Subject: AP1000 Response to Requests for Additional Information (TR 44)

Westinghouse is submitting a revised response to the NRC requests for additional information (RAIs) on AP1000 Standard Combined License Technical Report (TR) 44, APP-GW-GLR-026, "New Fuel Storage Rack Structural/Seismic Analysis." This RAI response is submitted in support of the AP1000 Design Certification Amendment Application (Docket No. 52-006). The information included in the response is generic and is expected to apply to all COL applications referencing the AP1000 Design Certification and the AP1000 Design Certification Amendment Application.

Response to Requests for Additional Information on Technical Report 44

Figure 44-2.1 Stress Strain Curve for SA240-304 Stainless Steel

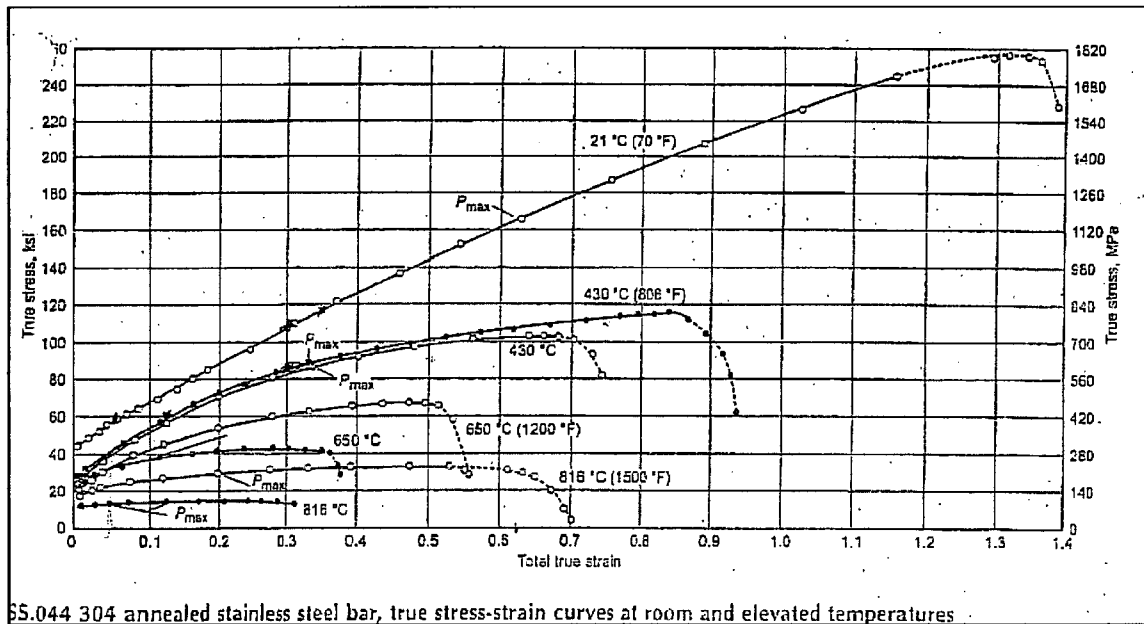
Section 2.8.5 states that appropriate non-linear material properties have been applied to the rack components to permit yielding and permanent deformation. Table 2-6 only provides Young's modulus, yield strength, and ultimate strength, which are not sufficient to define an engineering stress-strain curve. In addition, LYDYNA requires true stress-strain relation for its nonlinear materials. Therefore, provide the following: (1) a complete description of the material stress-strain curve and confirm that a true stress-strain curve was used in these impact analyses and (2) a description of the fuel assembly model, including the element properties and material properties for the dropped fuel assembly.

1) The new fuel racks are fabricated from SA240-304 and SA564-630 stainless steel. For the impact analyses, a true-stress strain curve, which is obtained from Atlas of Stress Strain Curves (2nd Edition, ASM International) and reproduced below as Figure TR44-2.1, is used to define the strength properties of SA240-304 stainless steel.

Figure 2-8 LS-DYNA Model of Dropped Fuel Assembly

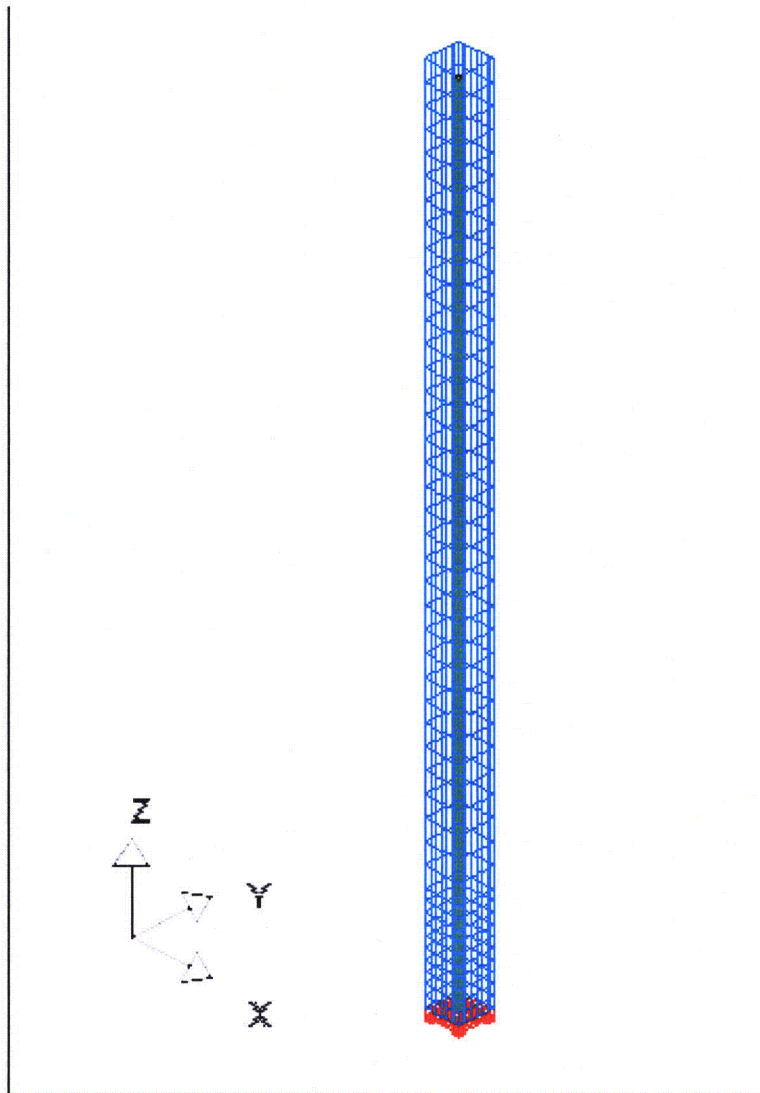
The baseplate in Figure 2-8 appears to have only one layer of 8 node brick element through its thickness. It is not clear if a solid or a thick shell element is used. Clarify the type of element used for the baseplate.

The similar spent fuel rack RAI-TR54-06 was resolved during the May 21 and 22, 2008 technical review. During the technical review, Westinghouse demonstrated that the rack baseplate model was revised to utilize thick shell elements in Revision 1 of APP-FS02-Z0C-001, "Analysis of AP1000 Fuel Storage Racks Subjected to Fuel Drop Accidents". Westinghouse also demonstrated that the model to use strain rate effects for the material properties was revised. The net effect of both improvements resulted in lower deformations. The staff found that the use of the thick shell element representation of the baseplate rather than one row of solid brick elements is acceptable and the use of strain rate effects is appropriate because it more closely simulates the true material behavior under dynamic impact loadings.

Figure TR44-05.1 Fuel Assembly Deep Drop Scenario 1 for New Fuel Rack

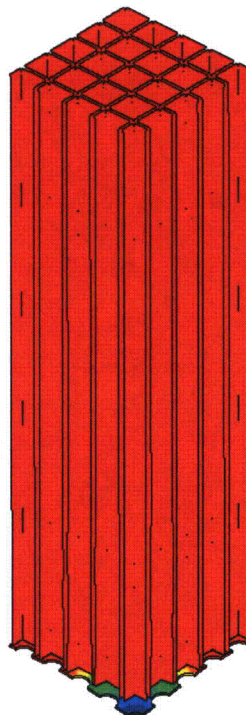
Section 2.8.5 does not indicate whether other fuel assemblies are in place, when a fuel assembly drops through an empty cell and impacts the baseplate at its center. Depending on how the baseplate is designed, a full load of fuel assemblies may introduce progressive deformation after a fuel assembly impacts at the center of the baseplate. The maximum downward deformation of the baseplate is about 3.8 inches, as shown in Figure 2-10. This may be significant enough to initiate a progressive deformation. Therefore, provide: (1) the assumption on the existing fuel assemblies when the impact occurs, (2) the design basis for the baseplate, and (3) a figure similar to Figure 2-10, that shows the cells together with the severely deformed baseplate.

- (3) Figure TR44-005.1 below shows the cells together with the severely deformed baseplate for the same LS-DYNA solution as shown in Figure 2-10. Note that the deformation of the cells is not significant compared to the baseplate. This is because the cell-to-baseplate weld connections break as a result of the postulated fuel impact load before the cell walls are permanently deformed.

Item 1: During the May 21 and 22, 2008 technical review of spent fuel rack RAI-TR54-09, Westinghouse demonstrated to the NRC staff that the model was revised to consider the effects of all of the stored fuel assemblies in the rack by modifying the density of the rack baseplate in Revision 1 of APP-FS02-Z0C-001, "Analysis of AP1000 Fuel Storage Racks Subjected to Fuel Drop Accidents". This revision to the model was made along with the use of thick shell elements for the baseplate and the inclusion of strain rate effects. The staff reviewed the calculation and confirmed that the approach utilizes the mass effect of all of the fuel assemblies by increasing the baseplate density. The staff concluded that the consideration of the rest of the fuel assemblies (excluding the single dropped fuel assembly) by increasing the mass of the baseplate is an acceptable approach to simulate the dynamic effects of the other fuel assemblies. Following the May 21 and 22, 2008 technical review this item was considered resolved. Westinghouse applied the same approach for the new fuel racks. Because the NRC staff has already reviewed and accepted Revision 1 of APP-FS02-Z0C-001, which also applies to the new fuel rack, Westinghouse considers this item to be resolved for the new fuel rack as well.

Figure 2-9 Results from Drop on AP1000 New Fuel Storage Rack

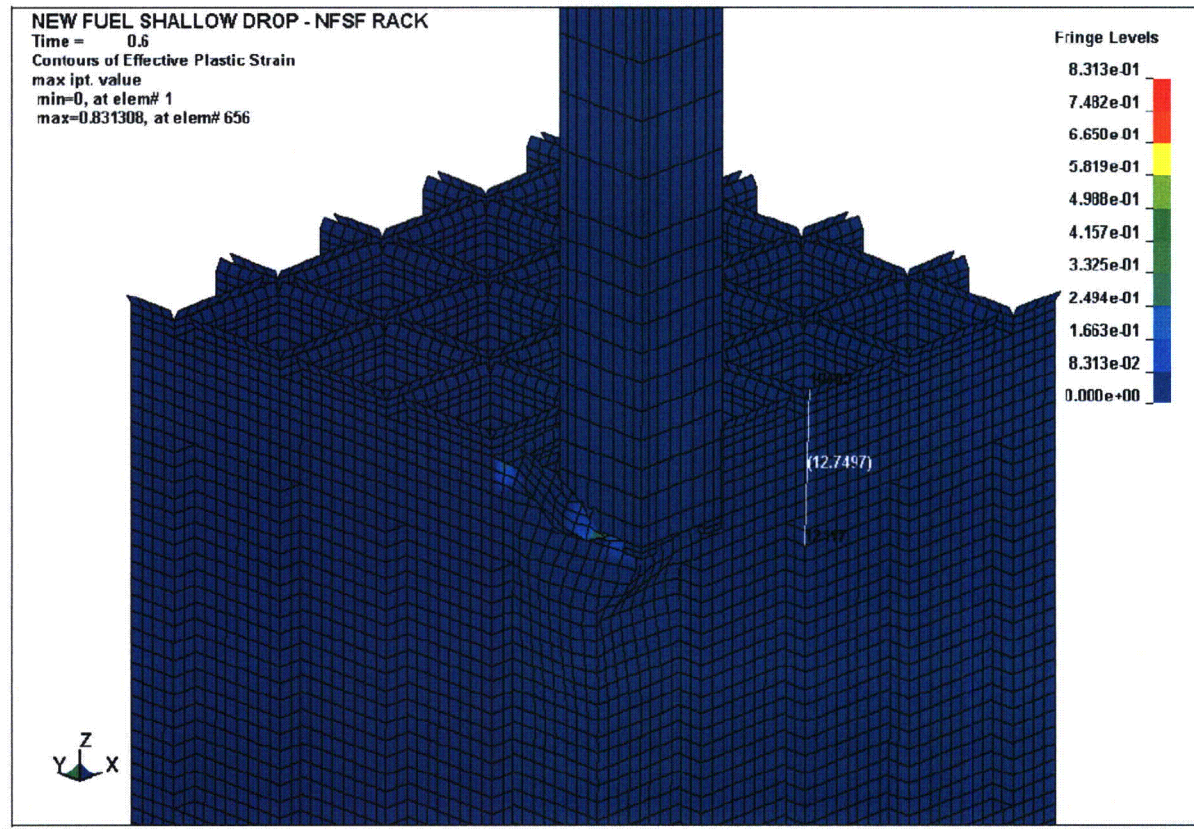
Figure 2-9 of this report shows the permanent deformation at the top of a cell wall. The permanent deformation is measured as 10.26 inches, which is smaller than the limit of 14 inches. However, the figure also shows indications of nontrivial hourglassing, which may significantly affect the accuracy of the analysis result. The mesh at the impact location should be locally refined, to ensure convergence with mesh size. Therefore, an additional analysis with a finer mesh at the impact region should be performed to confirm that the model is suitable.

Westinghouse provided these curves which demonstrated that the hourglass energy was essentially negligible in comparison to the internal energy of the cell structure and impact bar that were being plastically deformed during these drop accident cases. For the spent fuel racks, the NRC staff found the response to be technically acceptable in view of the much larger margins in the extent of plastic deformation in the new revised model, and the comparison of the hour glass energy. Following the May 21 and 22, 2008 technical review, this item was considered resolved for the spent fuel racks. Westinghouse applied this same approach for the new fuel racks; therefore, Westinghouse considers this additional item to be resolved for the new fuel racks as well.

Figure 2-9 was replaced with the following figure:

FIGURE TR44-9.1

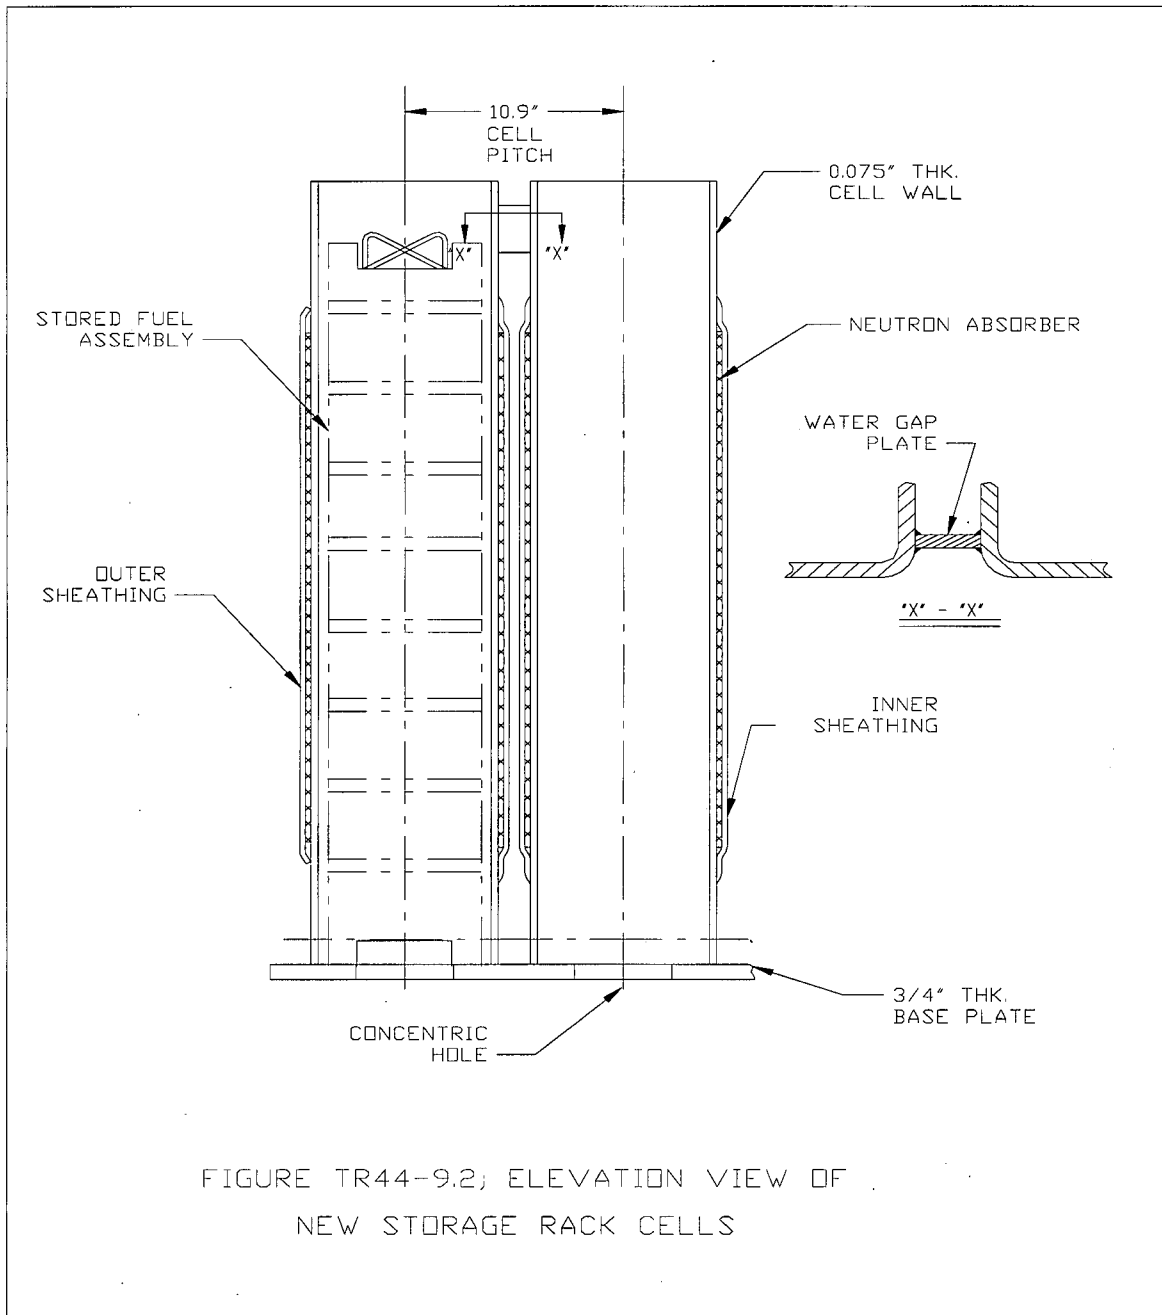
Insufficient descriptive information has been included in the new fuel report to permit an adequate review of the structural/seismic analysis of the new fuel rack. Please provide descriptive information including plans and sections showing the new fuel rack and vault walls. All of the major features of the rack including the cell walls, baseplate, pedestals, bearing pads, neutron absorber sheathing, any impact bars, welds connecting these parts, and any other elements in the load path of the rack should be shown on one or several sketches. These sketches should also indicate related information which includes key: cutouts, dimensions, material thicknesses, and gaps (fuel to cell, rack to walls). In addition to the above, for review of postulated fuel handling drop accident and quantification of the drop parameters, sketches with sufficient details for the fuel handling system should be provided.

Figures TR44-9.1 through TR-44-9.5 provide additional descriptive information on the new fuel rack and New Fuel Storage Pit floor and walls. The new fuel handling system is still in final design and no sketches are available. The quantification of the drop parameters has been established and analyzed in Technical Report Number 44. A conservative drop height of 36 inches has been assumed even though the most likely drop height will not exceed 18 inch above the new fuel rack. The total drop weight is 2,027 pounds, which consist of a new fuel assembly, control assembly and new fuel handling tool.

Figure 9.1-1 (Sheet 1 of 2)
New Fuel Storage Rack Layout (72 Storage Location)

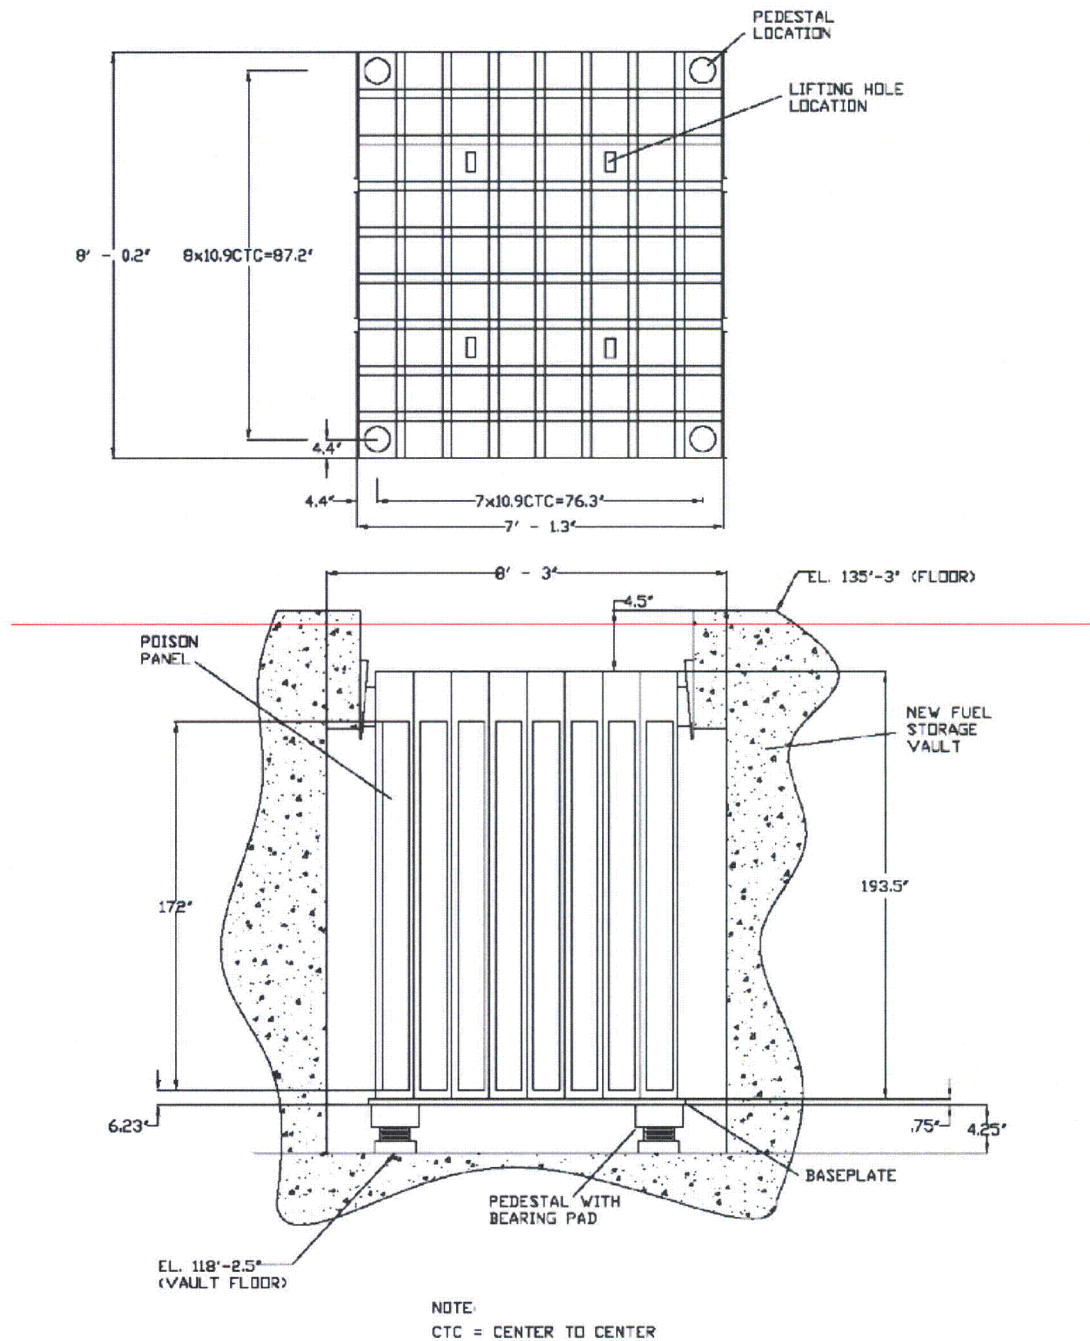
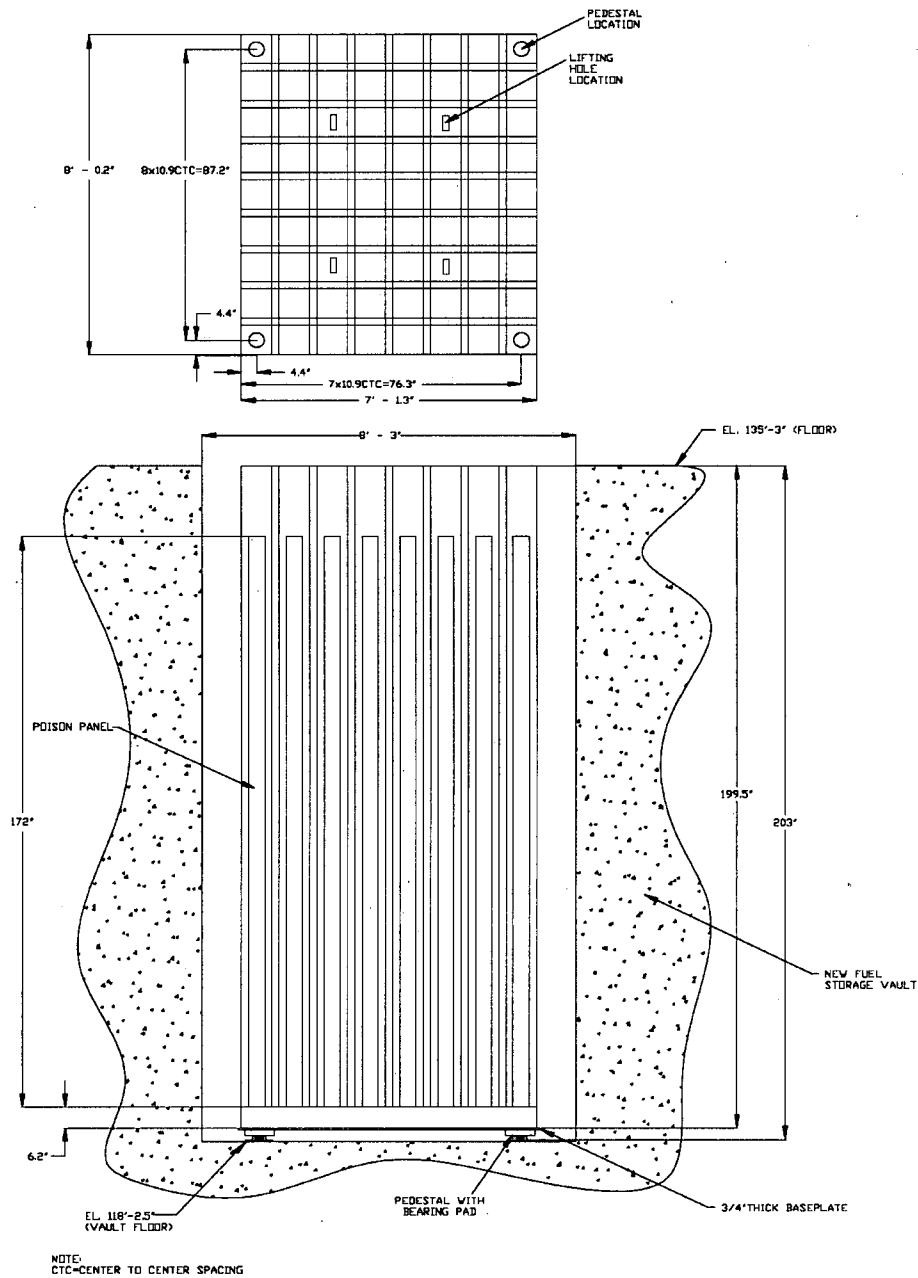
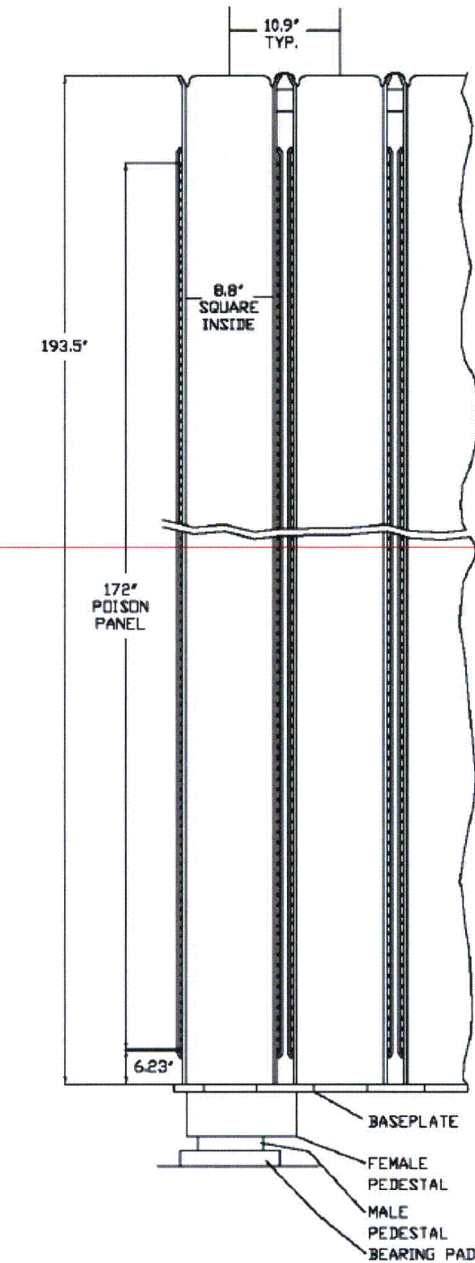
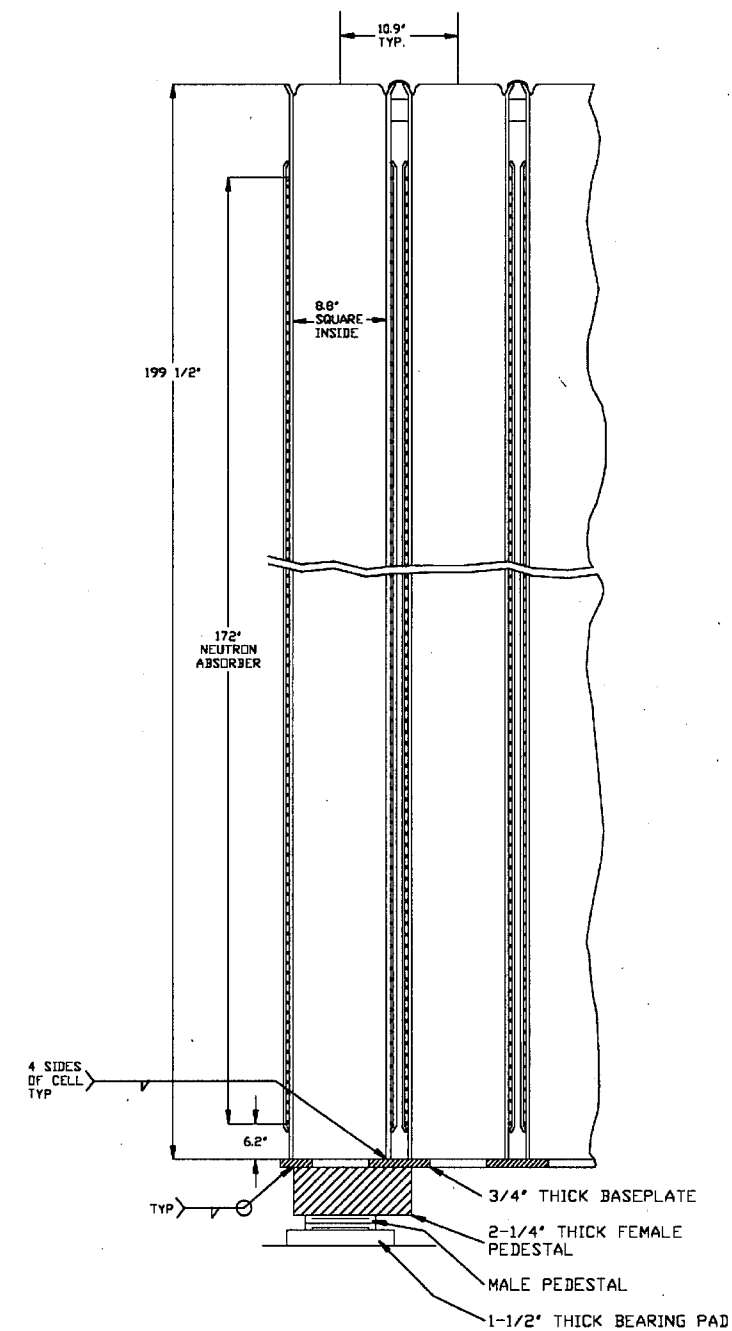
In the markup of the DCD, provided in Section 5 of the topical report, Figure 9.1-1, New Fuel Storage Rack, is identified for deletion. Please explain why you are deleting this figure. This figure should be retained in the DCD.

The two figures shown in the DCD and TR markup sections provide updates of the layout and cross section of the new fuel storage rack. The figures replaced Figure 2-1 of TR44 and DCD Figure 9.1-1, Sheets 1 and 2; see the DCD and TR markup sections for details.

Design Control Document (DCD) Revision:
Revise Figure 9.1-1, Sheets 1 and 2, as follows:

We are in agreement. Revision 16 of the DCD will have a revised Figure 9.1-1 New Fuel Rack Layout. This figure will show the new fuel rack configuration in plan and elevation views identifying significant features and dimensions.
